## RCWD BOARD OF MANAGERS REGULAR MEETING AGENDA

Wednesday, July 9, 2025, 9:00 a.m.

The purpose of this memorandum is to summarize the information and comments received, provide engineering responses (as appropriate) and identify how the information may be considered with respect to a decision on further management of ACD 10-22-32 in this location. The memorandum also will recommend next steps in proceeding forward with a management alternative.

Photo 1: Cracked Concrete Slab

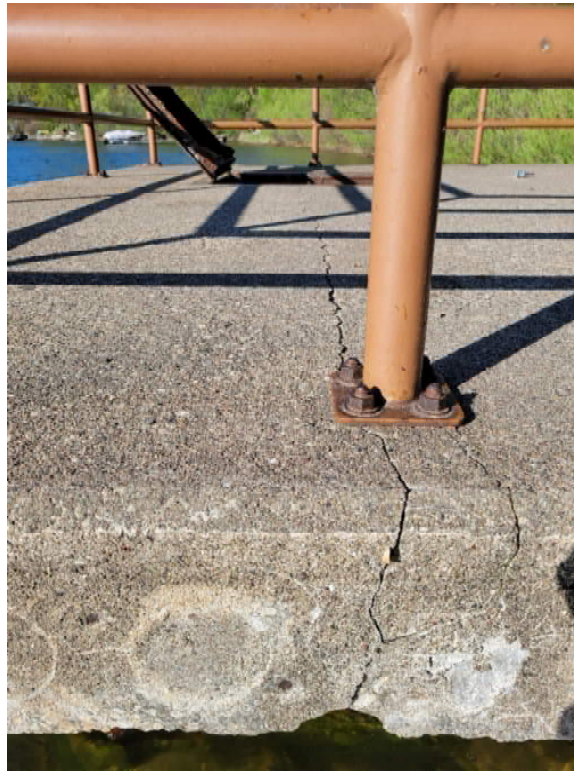
Of initial concern is the safety of the structure. The majority of the steel posts supporting the concrete platform have almost entirely rotted away at the connection to the sheet piling (see photos 2-5 below) and the concrete above is showing signs of stress, including a lateral crack across the top of the structure. The rail surrounding the underside of the platform is also severely rotted potentially allowing access to the underside of the structure. We recommend that Ramsey County immediately close the structure down from public access both to the top of the pier and the underside of the pier (as the protective railings near the water level are failing and couple potentially allow unauthorized access into the outlet structure).

The structure is deteriorated throughout, has a displaced skimmer and front sheet pile cap, and debris is clogging the overflow. The sheet piling surrounding the structure shows signs of damage and is severely rotted as well. It is unclear if the knife gate and pipe heading out into the lake are functionable. The deterioration is such that repairs are infeasible, and the structure requires a complete replacement.

Moving forward We recommend the RCWD and Ramsey County engage in discussions on future needs for the outlet structure. This may then be followed by the development of a plan to demo the existing pier/outlet structure and replace it with infrastructure that meets the current needs of the RCWD and Ramsey County.
